Economic and Social Council

Proposal for Supplement 11 to UN Regulation No. 109 (Retreaded tyres for commercial vehicles and their trailers)

Revision 1

Submitted by the Working Party on Noise and Tyres ^{*},^{**}

Figure, amend to read:

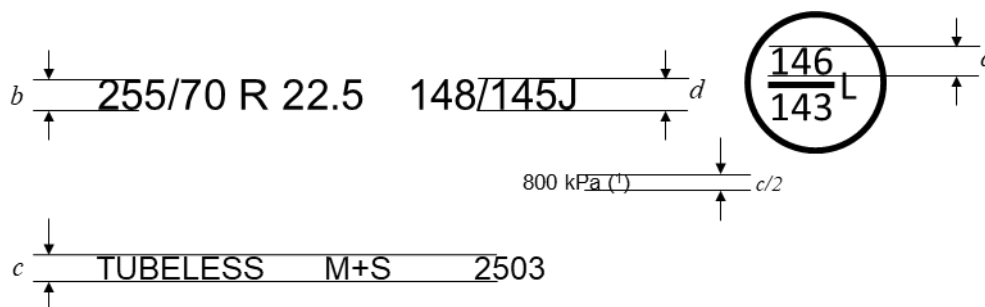
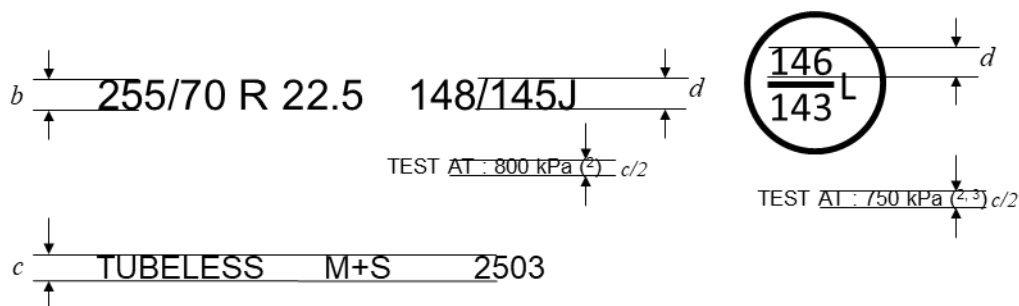
Annex 3,

Example 1:

- (1) PSI marking instead of kPa is allowed for tyres first type approved before 1 January 2018. The kPa marking may be preceded by "TEST AT : " or, alternatively, by "TEST INFL : " or the symbol "@".

Example 2:

- (2) "TEST AT : " may be replaced by "TEST INFL : " or the symbol "@" or be omitted.
 (3) The indication of a second inflation pressure for the additional service description is optional. If there is no indication, the same test inflation applies to both load/speed combinations.
